IREDELL COUNTY HEALTH DEPARTMENT

IMPROVEMENT PERMIT / AUTHORIZATION TO CONSTRUCT / OPERATION PERMIT / EXISTING SYSTEM INSPECTION

PERMIT# 117704 PIN# 4629-78-2986 DATE 2-12-04

SUBDIVISION CRESCENT LANDING BLOCK / SECTION 18 LOT 801 LOT AREA .81AC SITE CLASS PS DESIGN FLOW 360 L.T.A.R. .3

INITIAL SITE SKETCH 1" = 50'

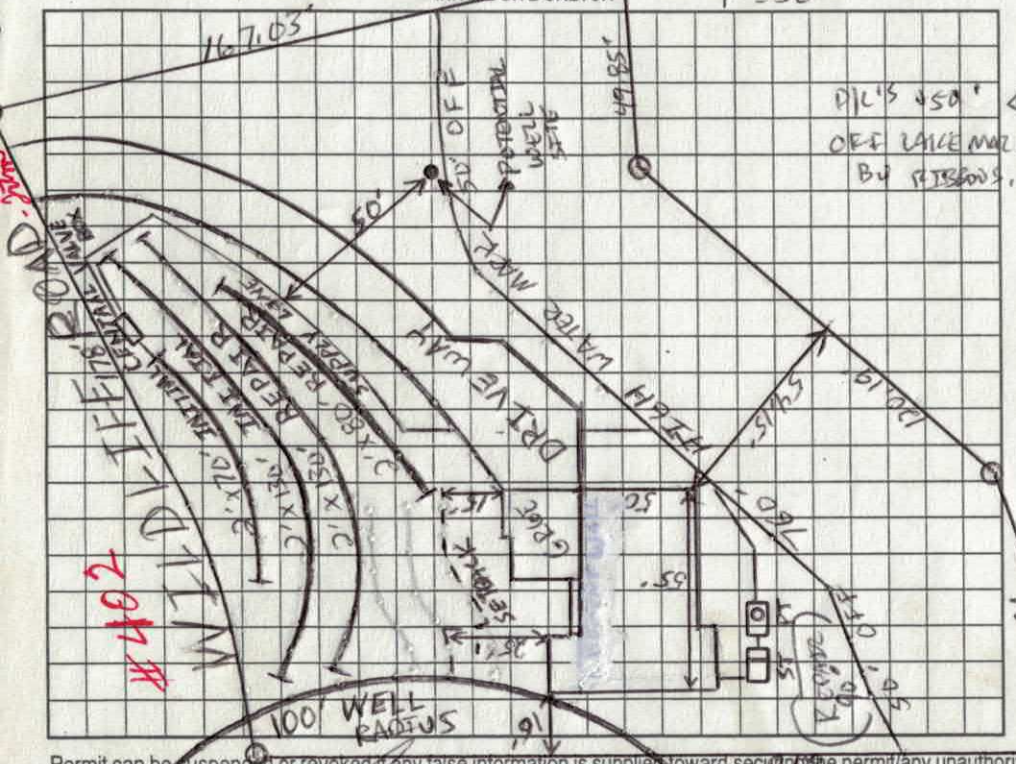
Comments:/Conditions: (1) SYSTEM + HOUSE ARE ENTIRELY FLAGGED OUT ON LOT (2) DRIVEWAY MUST NOT BE CUT. IT MUST REMAIN AT NATURAL GRADE OR THE REPAIR WILL NOT BE VALID. (3) SUPPLY LINE CROSSING UNDER THE DRIVE MUST BE DONE IN ACCORDANCE OR RULE 1950(C)(e).

(4) DO NOT CUT LOT FOR POSITIVE DRAINAGE REQMTS. KEEP HOUSE OUT OF THE GROUND + BACK FILL FOR POS. DRAINAGE. THIS CHANGES THE CUT SETBACK OF 35' to 15" FOR FILLING IT.

(5) THIS IS A LOW PRESSURE PANEL SYSTEM + A MAINTENANCE CONTRACT MUST BE EXECUTED BY OP IS SIGNED.

AS BUILT SKETCH

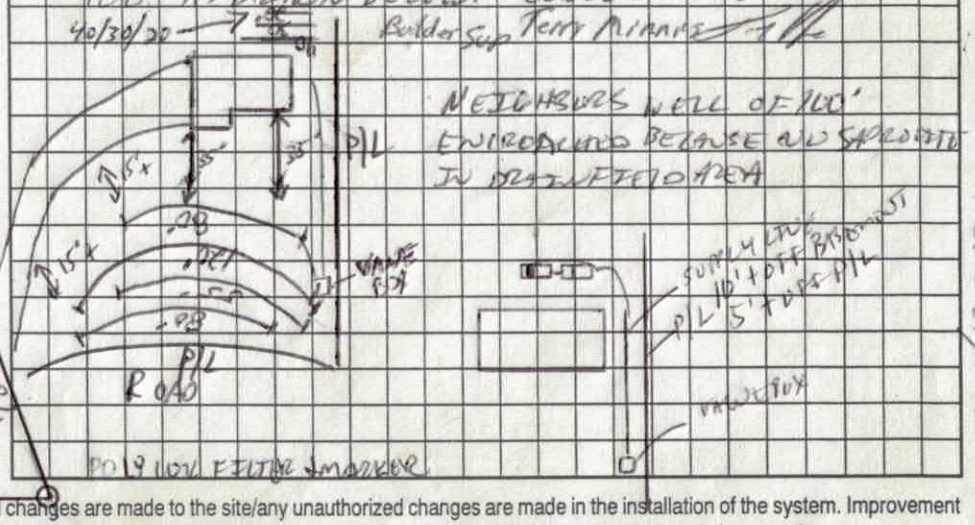
(6) NEEDS BACKFILLED SO LAST 2' OF DRIVE WILL BE 15' OFF CUT WENT + FLAGGED OUT SYSTEM BY INSTALLATION HOUSE + DRIVEWAY WAS NOT. CHANGES WERE MADE TO INSTALL + REPAIR TO GET TOTAL LENGTH OF 400'. AS SHOWN BELOW. CURVE LOOKS AS

NEIGHBORS WELL OF 400' ENCROACHED BECAUSE OF SEPTIC IN DESIGNATED AREA

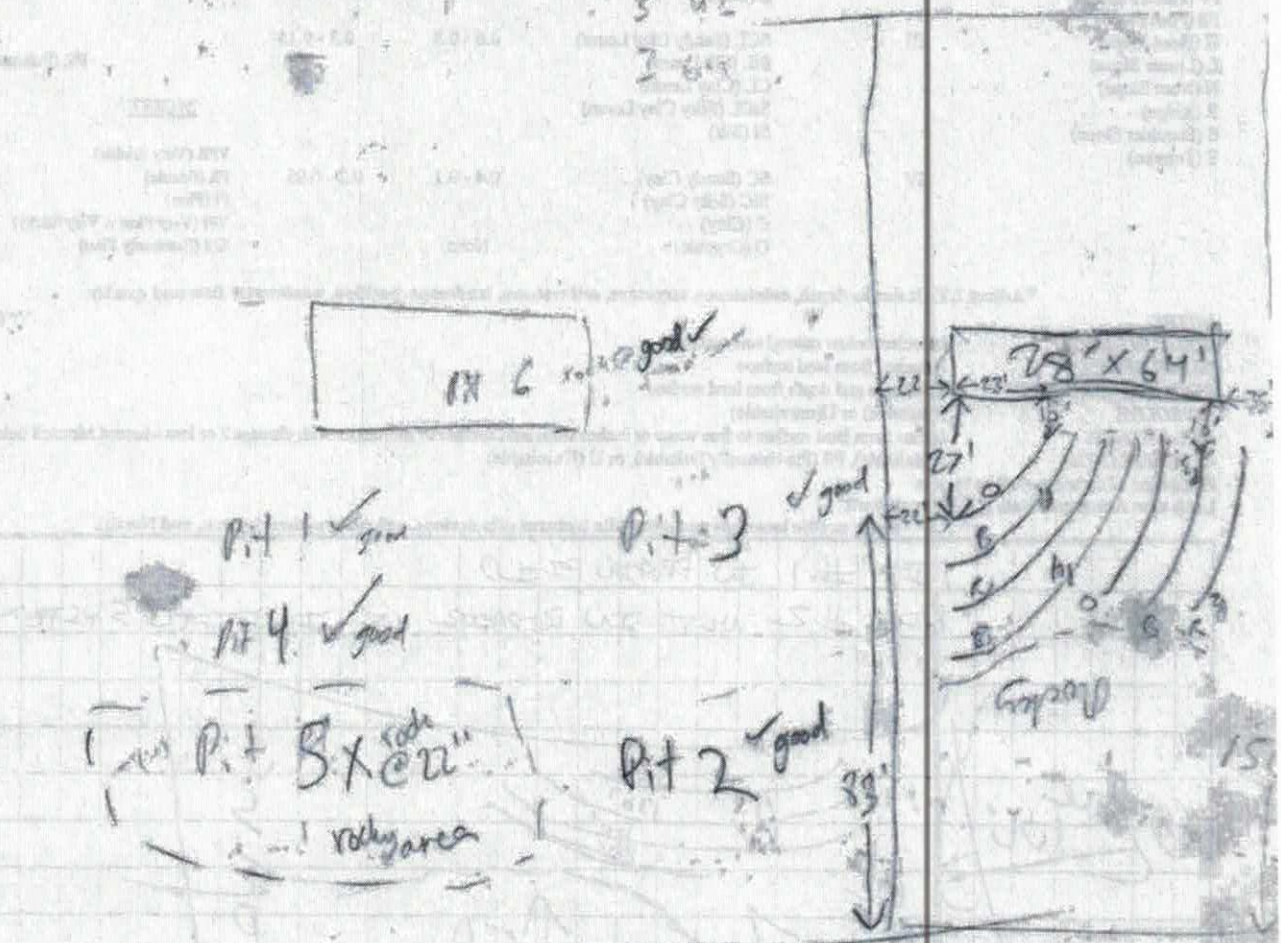
COMMENTS:
L7 WELL NEEDS 50' ENCROACHMENT AGREEMENT FROM THE STATE

INITIAL SITE SKETCH

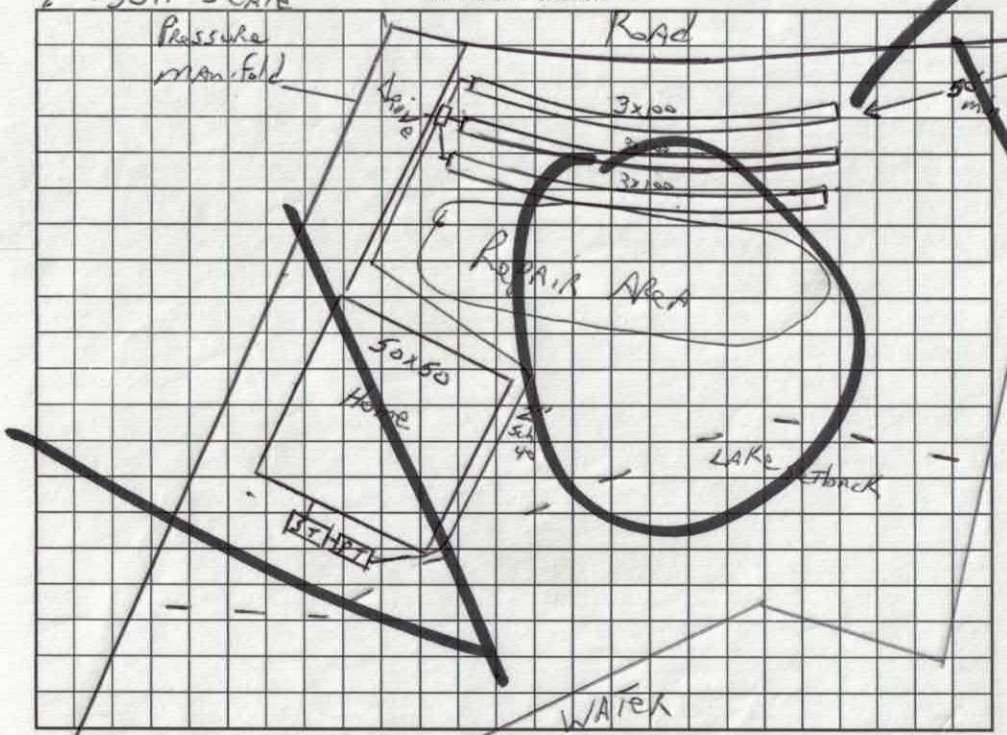
Comments:/Conditions: Install on Contour
